Product Change Notification

1. ECR #: 25-25864-1
Notification #: 777

- BE70A - 70 GHz BULLS EYE DOUBLE ROW
- BE70C - GEN 3 BULLSEYE PROBE CABLE ASSEMBLY

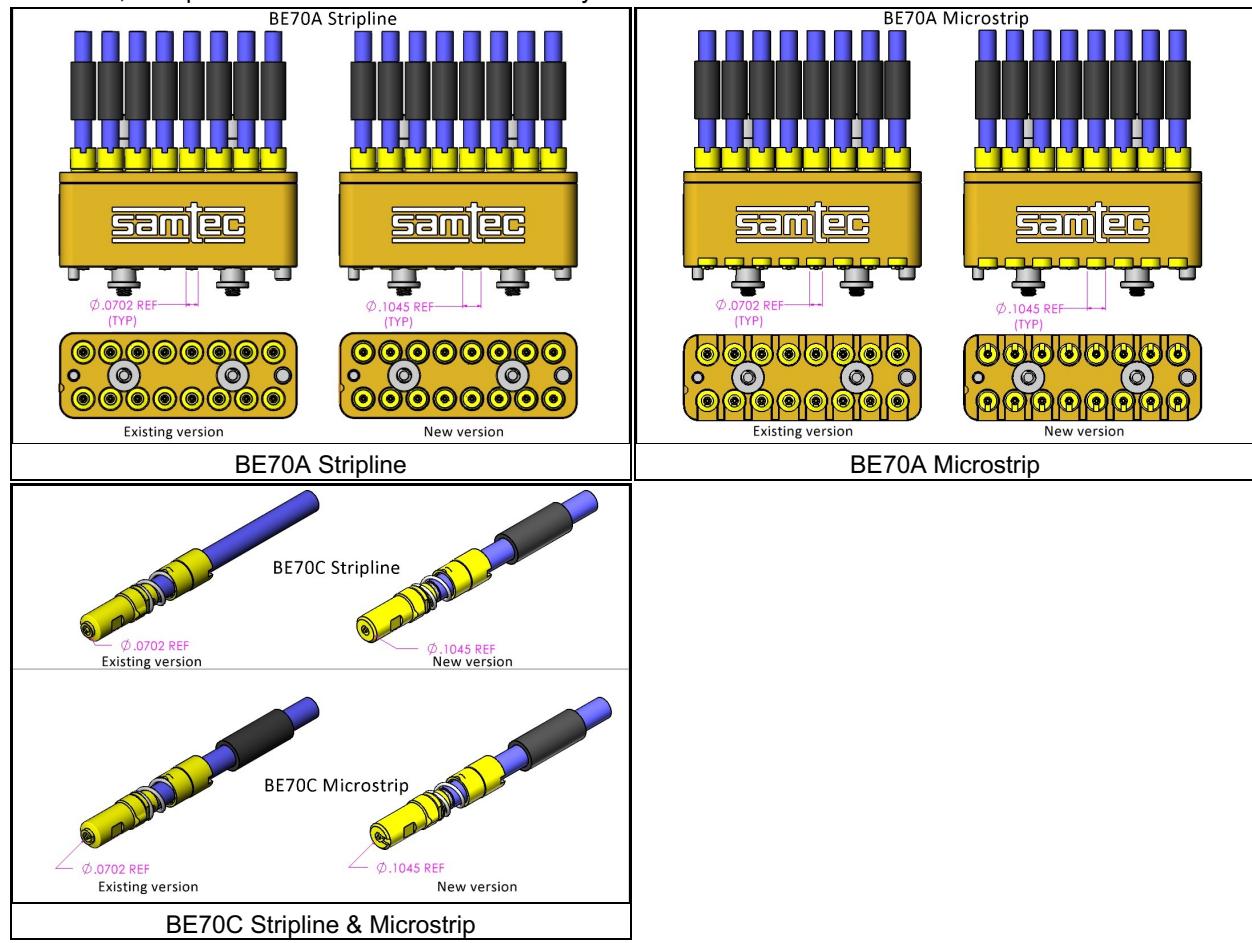
Tip of shell from BE70C cable assembly were increased from Dia.0702 inch to Dia.1045 inch.

When viewing old and new parts simultaneously, the newer version can be seen with naked eye to have the wider tip of shell. Also, the tip of shell can be measured to identify the versions.

More stable mechanical stability with the wider surfaces.

- Form - Tip of shell from BE70C cable assemblies are wider.
